MAG Standard Specifications and Details Committee
TENTATIVE AGENDA
March 6, 2013

MEETING MINUTES FROM THE
MARICOPA ASSOCIATION OF GOVERNMENTS
STANDARD SPECIFICATIONS AND DETAILS COMMITTEE

9. Case 13-04: Revision to Detail 120 SURVEY MARKER

**CASE 13-04
(02-22-2013)**

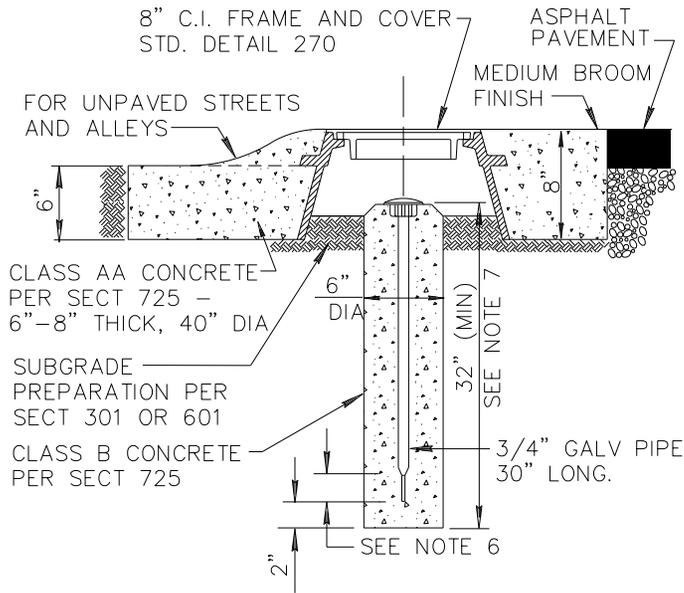
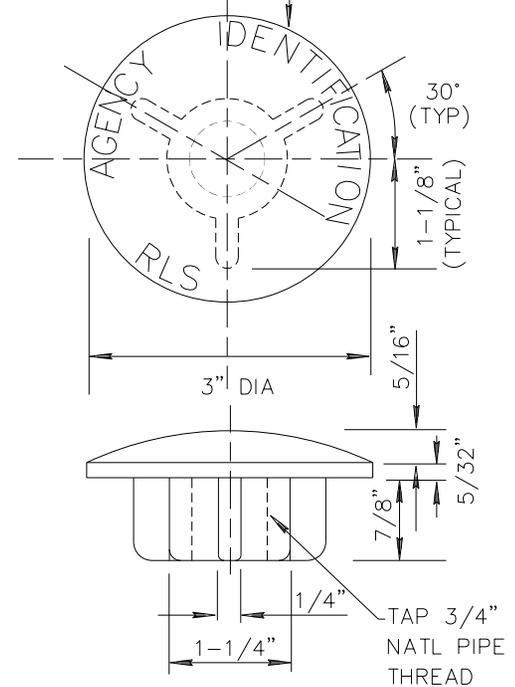
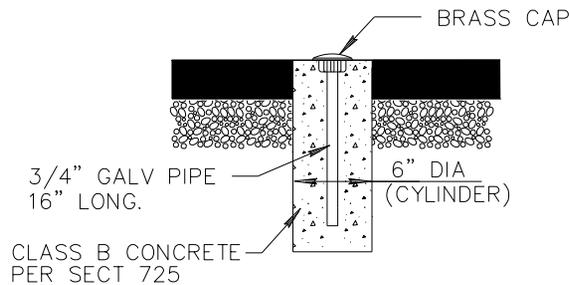
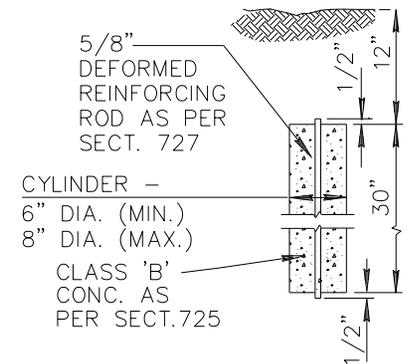
Revise detail to prevent installation of survey markers that do not comply with requirements of ARS 33-103. Bob Herz presented a new case to update Detail 120: Survey Marker to comply with state law requiring the markers to be located magnetically. To do this, he proposed replacing the Type A monument with MCDOT's Type E, and the Type B monument with Type D. The packet included letters from the MCDOT Survey Chief, a response from the Arizona Professional Land Surveyors Association, a copy of the state law, ARS 33-103, and the Arizona Boundary Survey Minimum Standards. Mr. Herz also handed out a new Detail 120 that replaces MAG details 120-1 and 120-2 and includes the new markers A and B. Mr. Herz explained that right now MAG's details require adding a washer to make it detectable, but often this washer is missing.

Jim Badowich notices that the chamfer on the Type B detail would make it difficult to fill in the asphalt around the top chamfer. Bob Herz agreed and said he could remove the chamfer. Besides Maricopa County, surveyors from Mesa and Tempe support the change.

Mr. Herz said he left the Type C marker on the detail but questioned the need for it. Bob Draper said Mesa uses them in subdivisions on rare occasions and suggested leaving it in.
